SERVICE BULLETIN # 00232

SUBJECT: Installation of a Plastic Anti-Bridging Baffle

MODELS: MIV, Milk Merchandiser

Figure A

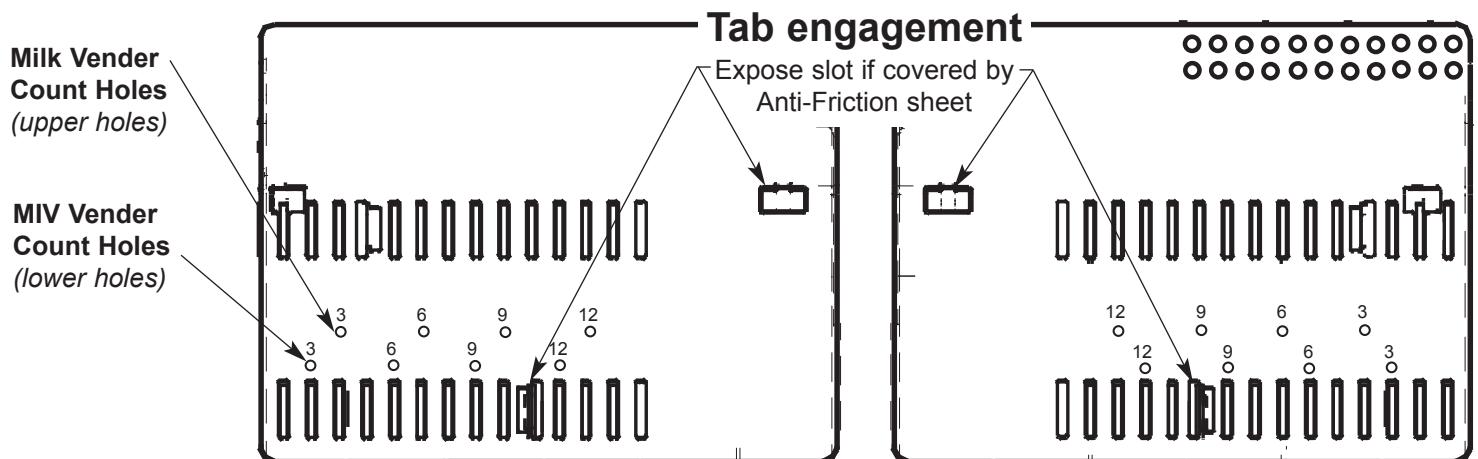
REASON FOR BULLETIN: To reduce the problems associated with product "bridging."

1. Unload column to be retrofitted.
2. Remove product retainers from column, if present.
3. Using a utility knife carefully cut out the corresponding holes through the anti-bridging sheet to insert the plastic baffle hooks and locking tabs or remove anti-bridging sheets.
4. Insert hooks of the plastic baffle into the corresponding rectangular slots in the metal baffle (see figure B). Then for the MIV Vender, snap locking tabs from the plastic baffle into slot 5 in the top row and slot 11 of the bottom row. For the Milk Vender, snap locking tabs into slot 4 in the top row and slot 10 of the bottom row. Refer to figure A
5. Use product retainer from the kit and set to desired product setting.

1. Unload column to be retrofitted.
2. Remove product retainers from column, if present.
3. Using a utility knife carefully cut out the corresponding rectangular slots in the metal baffle through the anti-bridging sheet to insert the plastic baffle hooks and locking tabs or remove anti-bridging sheets.
4. Insert hooks of the plastic baffle into the corresponding holes (see figure B). Then for the MIV Vender, snap locking tabs from the plastic baffle into slot 4 in the top row and slot 10 of the bottom row. For the Milk Vender, snap locking tabs into slot 3 in the top row and slot 9 of the bottom row. Refer to figure A
